Groundwater Transfer Review Summary Form

Transfer/PA # T- 14850

Ground Water Review Form:

Application: T-14850

Theis Interference Analysis

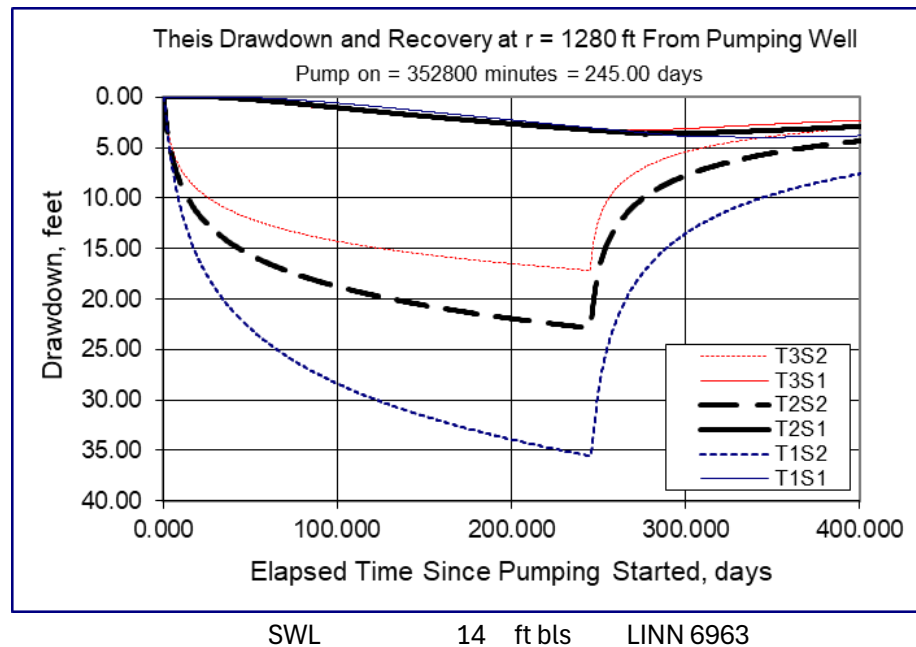
☐ Yes ☒ No If yes, explain: The to-POA (LINN 6963) is approximately 1,280 ft from the likely location of the TL 2200 well. The Theis (1935) solution for drawdown was used to assess the potential for injury to the TL 2200 well from the proposed changes (see attached Theis Interference Analysis). Results indicate the proposed change is unlikely to result in the TL 2200 well not receiving the water to which it is legally entitled.

The to-POA (LINN 6963) could not pump the combined rate for the full 245-day irrigation season without exceeding the combined duty. For the maximum combined duty of 274.2 AF, the maximum combined rate is 0.564256 cfs (253 gpm).

Aquifer Bottom	80	ft bls	Woodward et al., 1998
Available Water Column	66	ft	Aquifer bottom-SWL
Pump Height Above Bottom	5	ft	Estimate
NPSHa	5	ft	Estimate
Drawdown	2	ft	Theis, 1935 and pump test data
Minimum Water Column	12	ft	Estimated Drawdown + NPSHa + Pump Height
Injury	54	ft	Available Water Column-Minimum Water Column

Stream Depletion Analysis

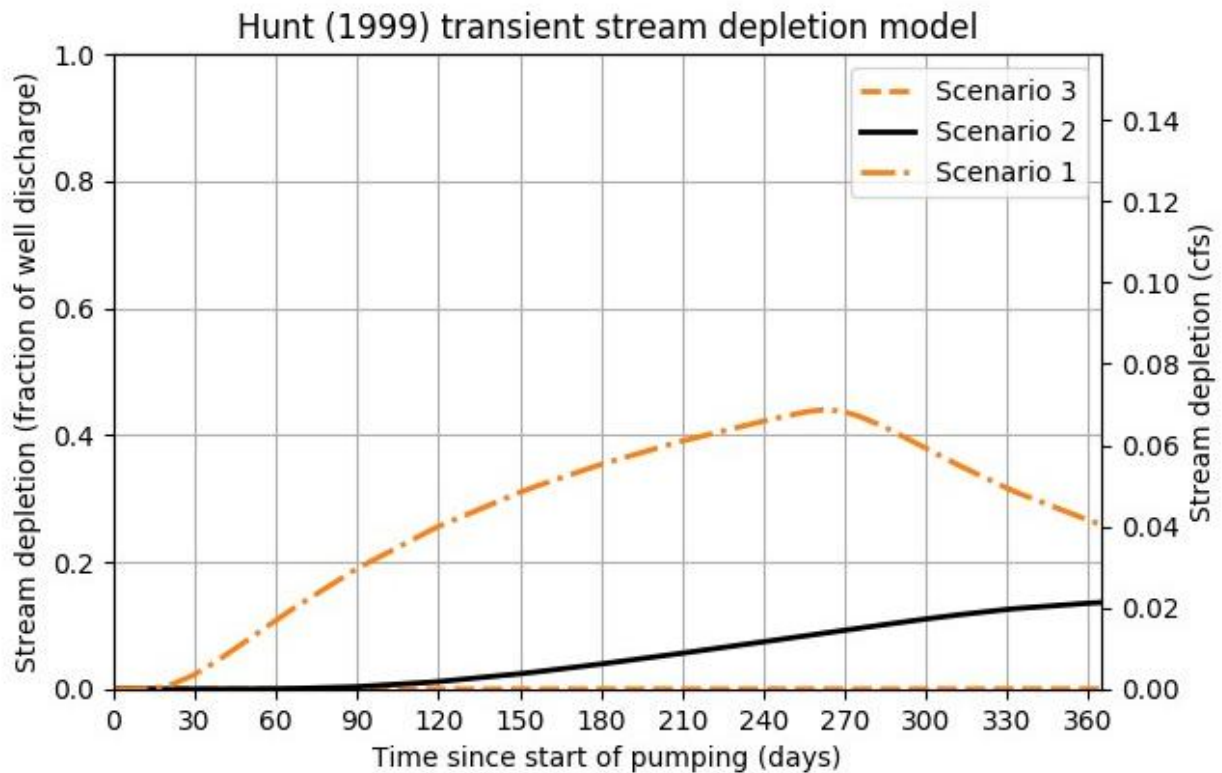
Provide context for minimal/significant impact: The expected increase in depletion from the South Santiam River was assessed using the Hunt (1999) analytical model for stream depletion due to pumping in an unconfined aquifer (see attached Stream Depletion Analysis). Results indicated that stream depletion due to pumping could likely increase by 2% of the rate of withdrawal after 245 days of continuous pumping as a result of the proposed change. Assuming that the to-POA (LINN 6963) was to pump at the maximum rate of 0.156 cfs (70 gpm)* over the full 245 days, the proposed change could result in an additional 1.277 cfs (573 gpm) of depletions to the South Santiam River by the end of the irrigation season. The South Santiam River WAB with the lowest month of natural stream flow is 253 cfs in September; the Net Water Available in September is -224 cfs. The to-POA (LINN 6963) is located closer to the mouth of the South Santiam River than the from-POA (LINN 9988). The change in degree of interference with the South Santiam River by the to-POA (LINN 6963) is anticipated to be minimal.

From-POA (LINN 9988) to South Santiam River

To-POA (LINN 6963) to South Santiam River
